SERIAL: BSEP 01-0041

BRUNSWICK STEAM ELECTRIC PLANT, UNIT NOS. 1 AND 2
DOCKET NOS. 50-325 AND 50-324/LICENSE NOS. DPR-71 AND DPR-62
REVISIONS TO PLANT EMERGENCY PROCEDURES

Summary of Revisions

Control Room Emergency Communicator Flow Chart

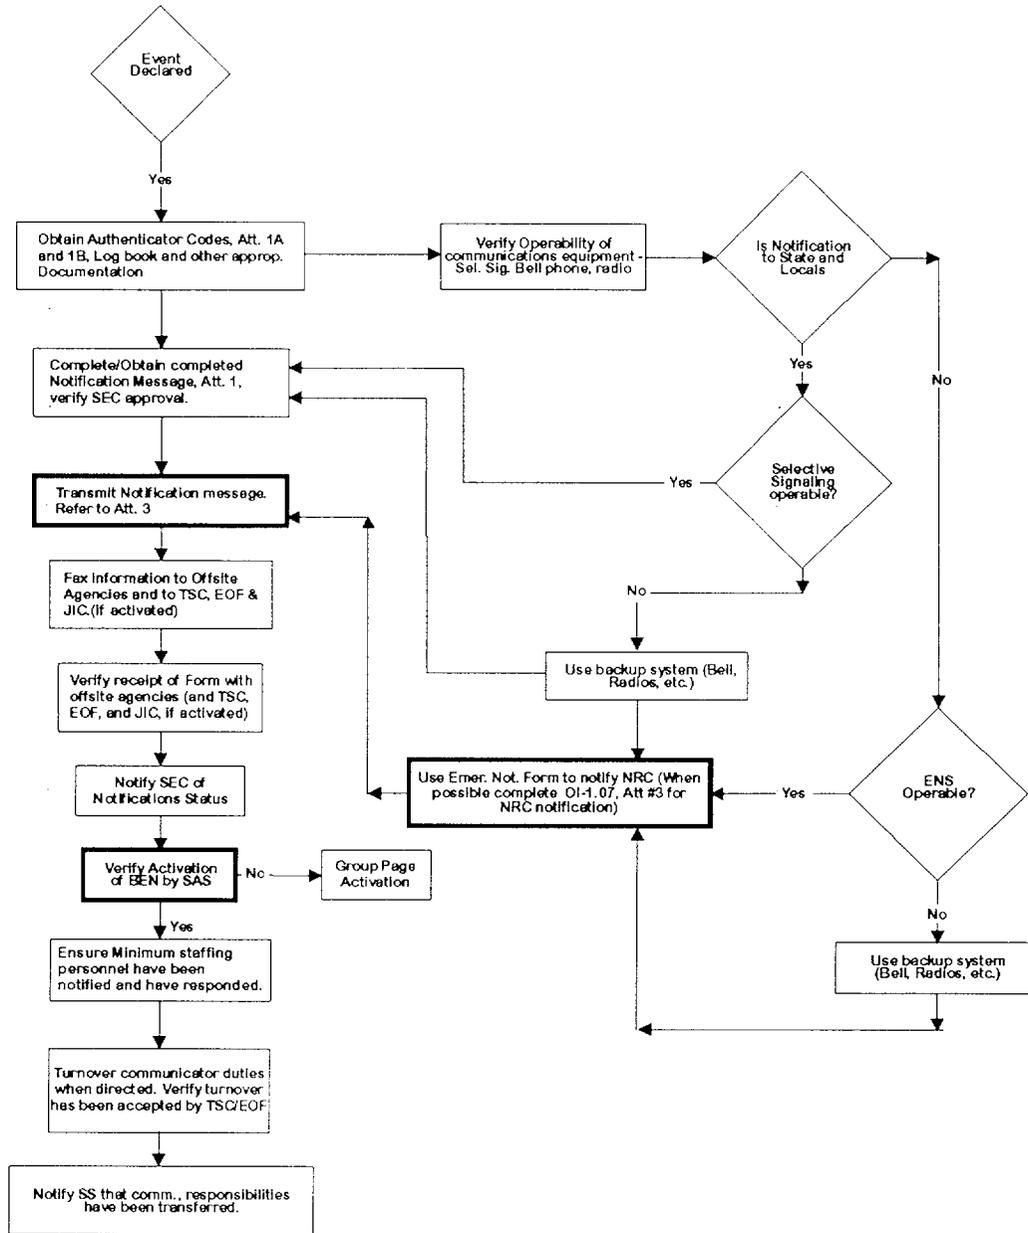
5. Removed a reference to FTS-2000 telephones in Attachment 3 to reflect changes to the Emergency Telecommunications System;
 6. Revised Attachment 6, "Control Room Emergency Communicator Flow Chart," to correct the flow chart processes; and

ATTACHMENT 2
Page 1 of 1
Emergency Operations Facility (EOF) Recommended Layout
Room 122/123

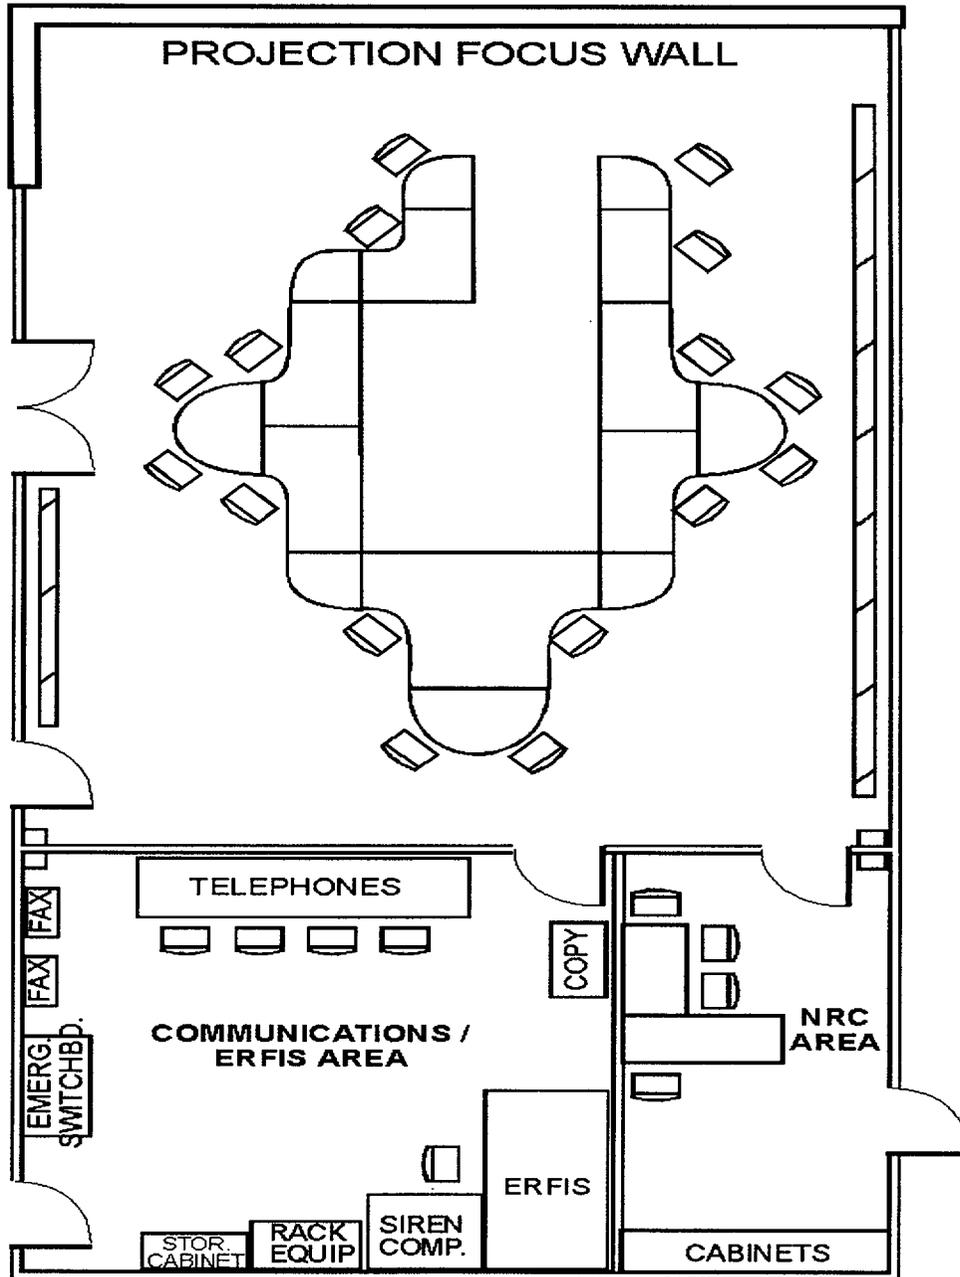
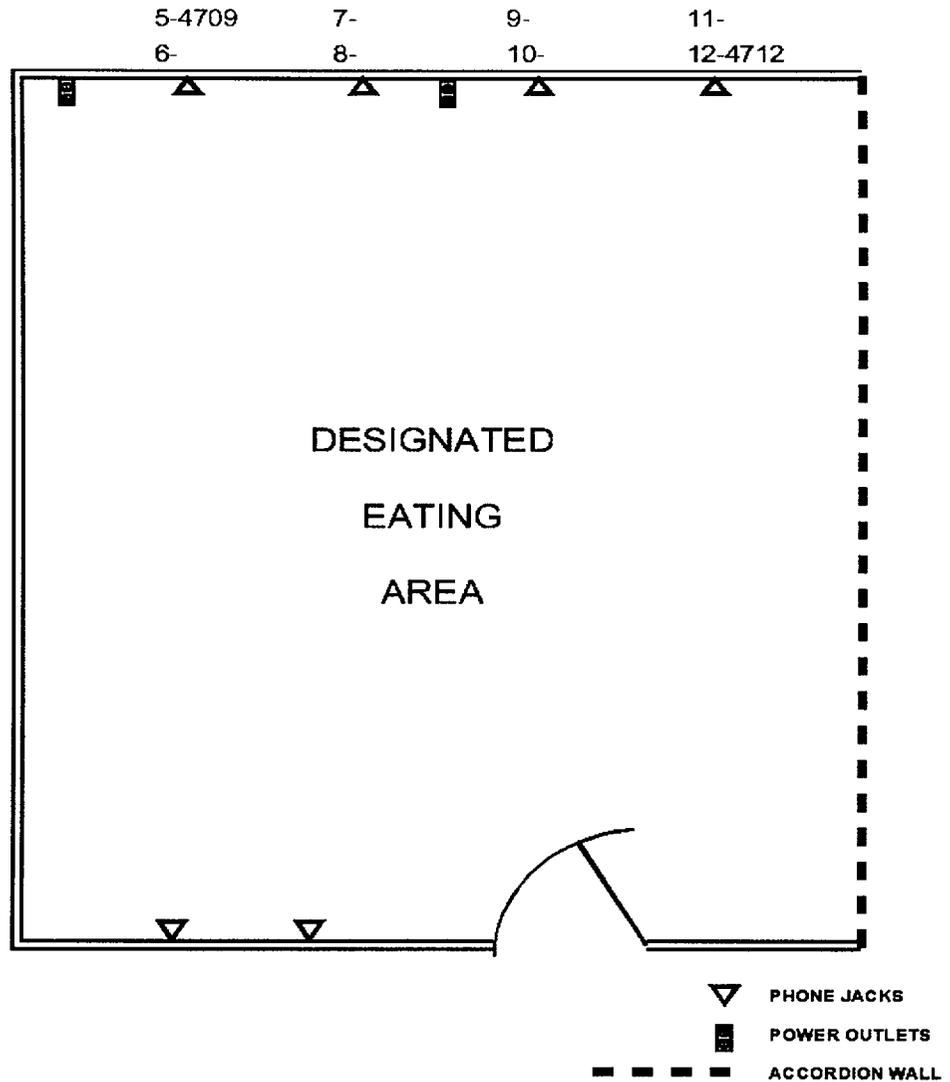
4. Revised Section 5.14.8 to provide additional guidance for the HPN Communicator when making NRC notifications;
 5. Revised Attachments 2, 3, 4, and 5 to reflect changes in the EOF layout; and
